Sinclair College
Building 14 – EMS Classrooms & Sim Lab
FAC 24-28X
Dayton, OH

ADDENDUM 01

Date of Addendum: January 31, 2025

This addendum consists of five (5) pages plus attachments.

1 PARTIAL LOWER LEVEL FLOOR PLAN
 1/8" = 1'-0"

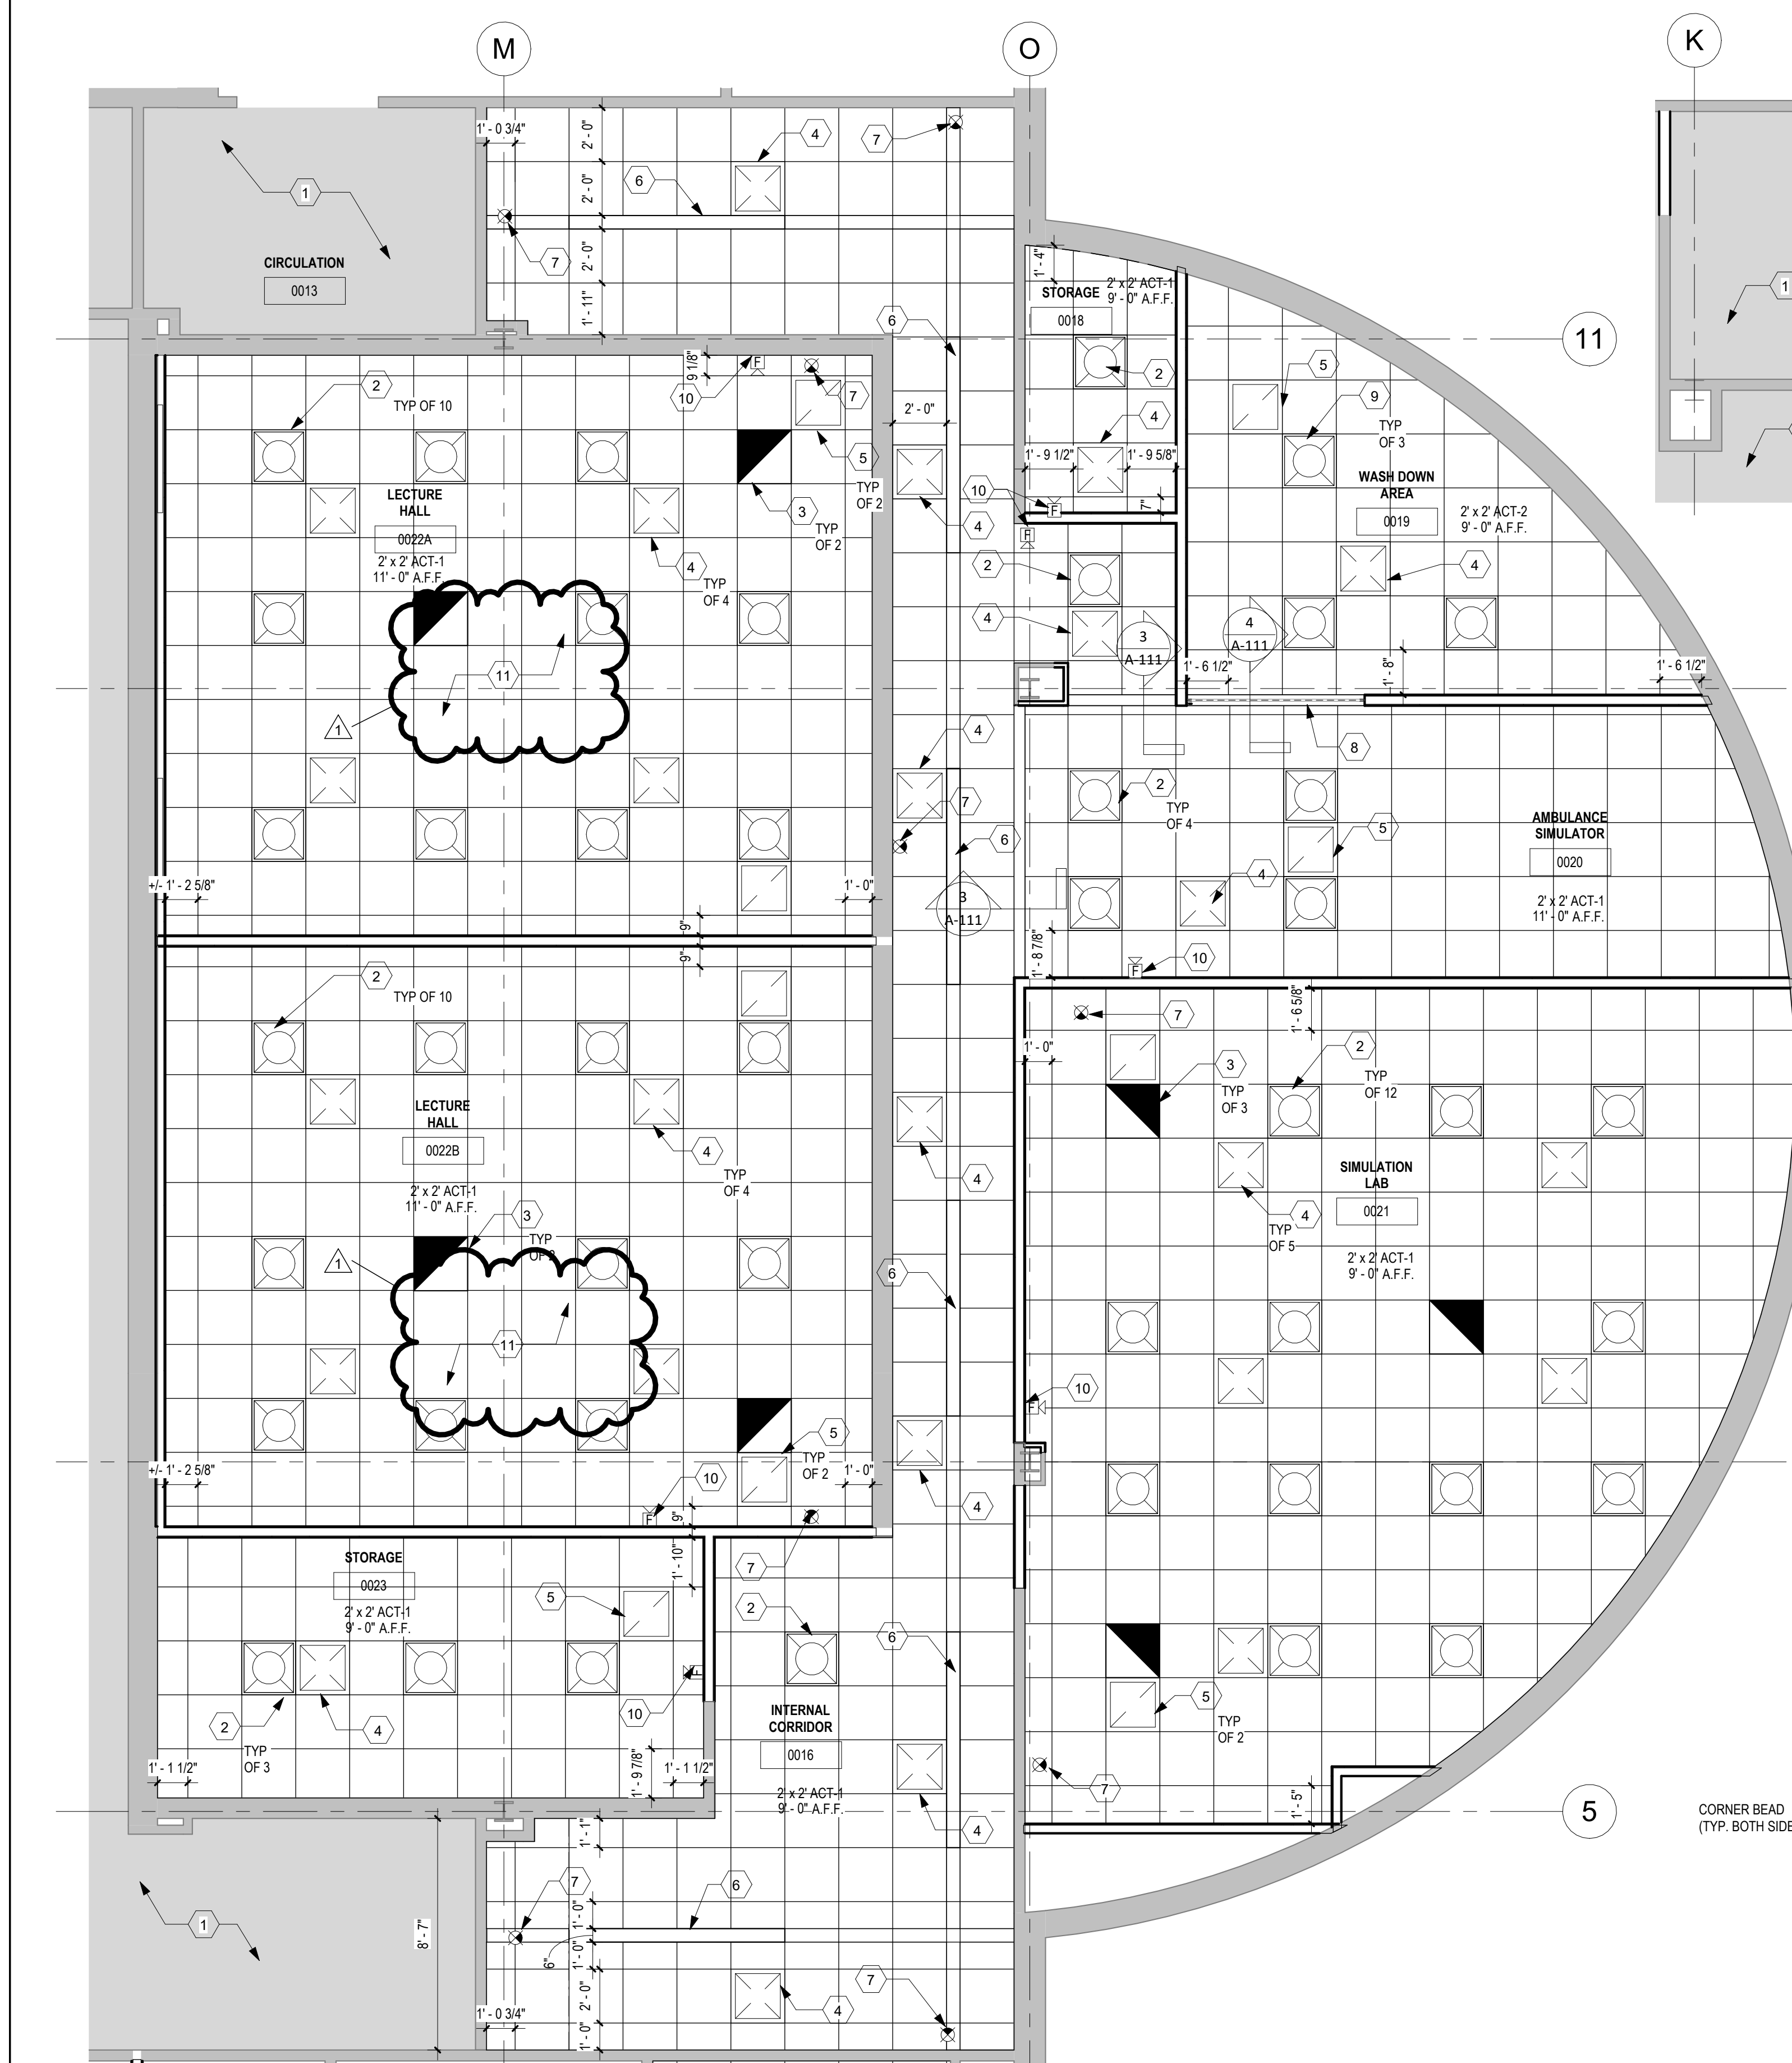
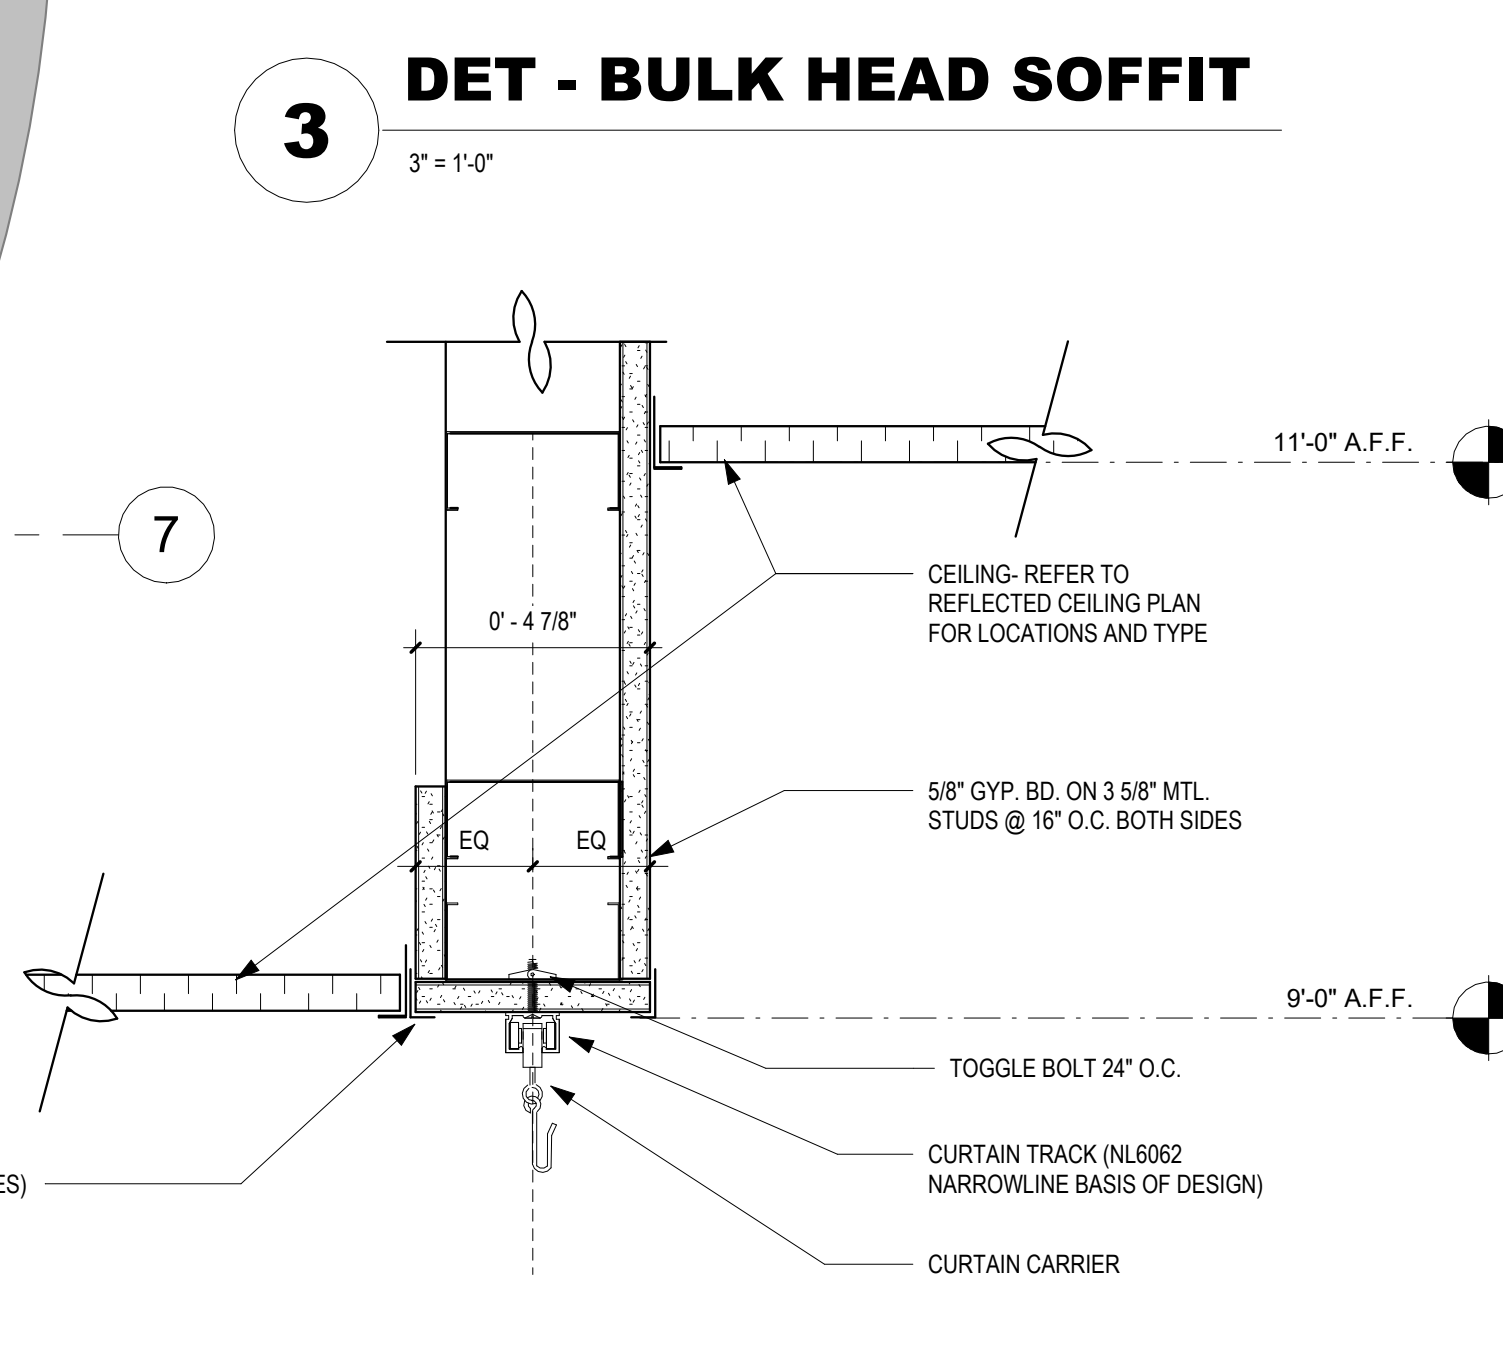
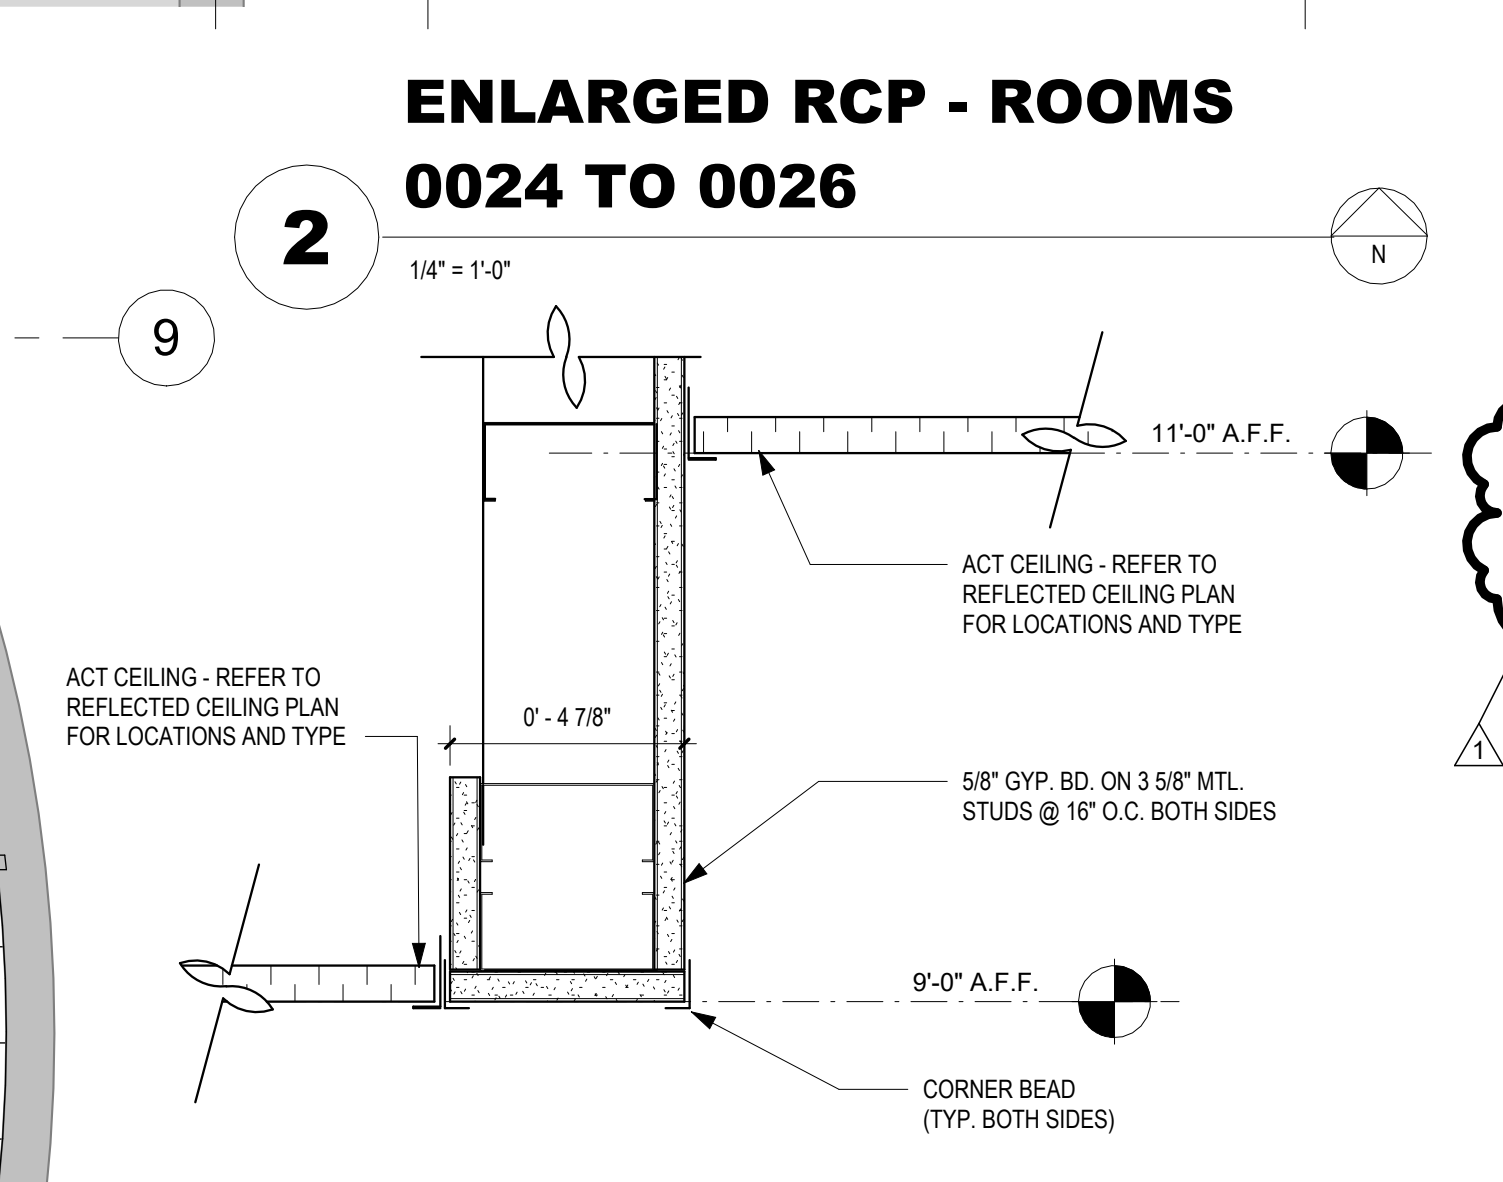
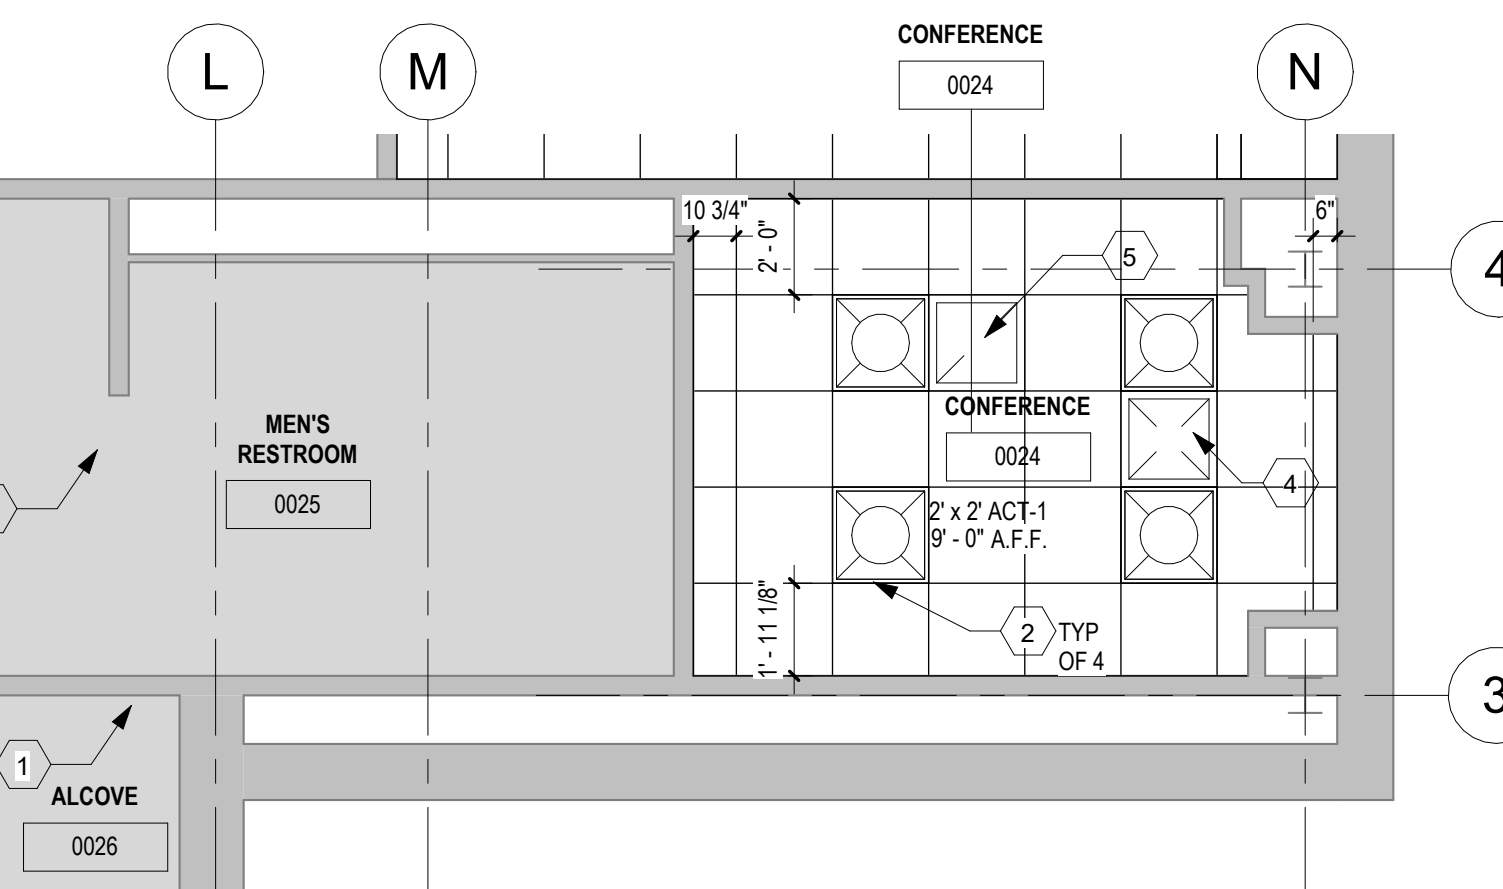
1. Sheet A-101 PARTIAL LOWER LEVEL FLOOR PLAN:
 - a. Add “ALLOWANCE NO. 1” designation to CODED NOTE 1.

- ALLOWANCE NO. 1 - PARTIAL HEIGHT SYSTEMS PARTITION, DOOR AND FRAME PROVIDED BY OWNER
- BID ALTERNATE - PATCH, PRIME, PAINT GYP PARTITION AT REMOVED OPENING.
- BID ALTERNATE - PROVIDE DOOR(S), FRAME & ASSOCIATED HARDWARE.

ENLARGED LOWER LEVEL FLOOR REFLECTED CEILING PLANS

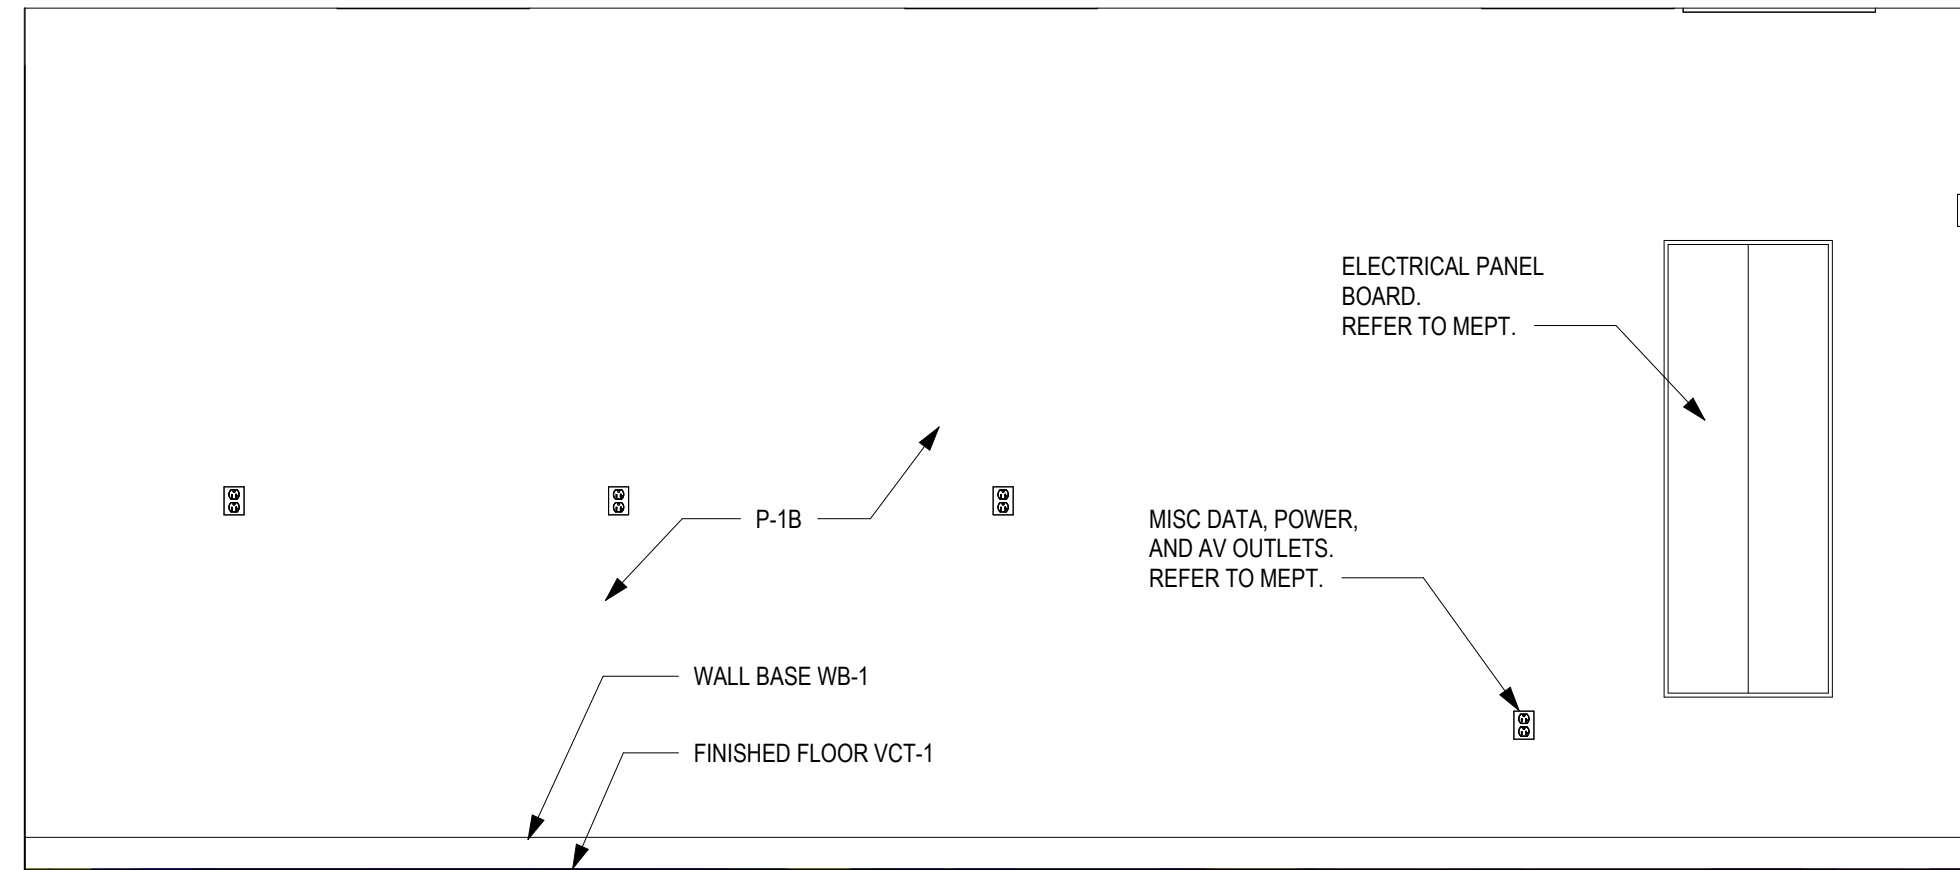
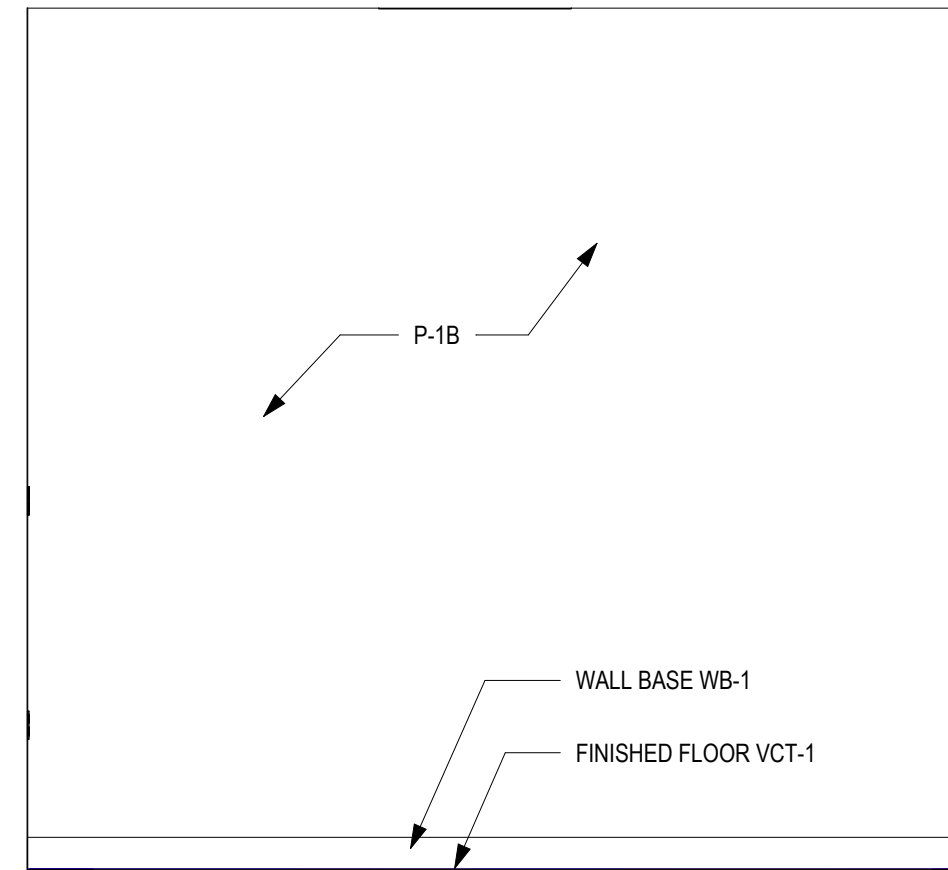
2. Sheet A-111 ENLARGED LOWER LEVEL REFLECTED CEILING PLANS:
 - a. Add coded note 11 to lecture halls.
3. Sheet A-412 LOWER LEVEL INTERIOR ELEVATIONS CONT.
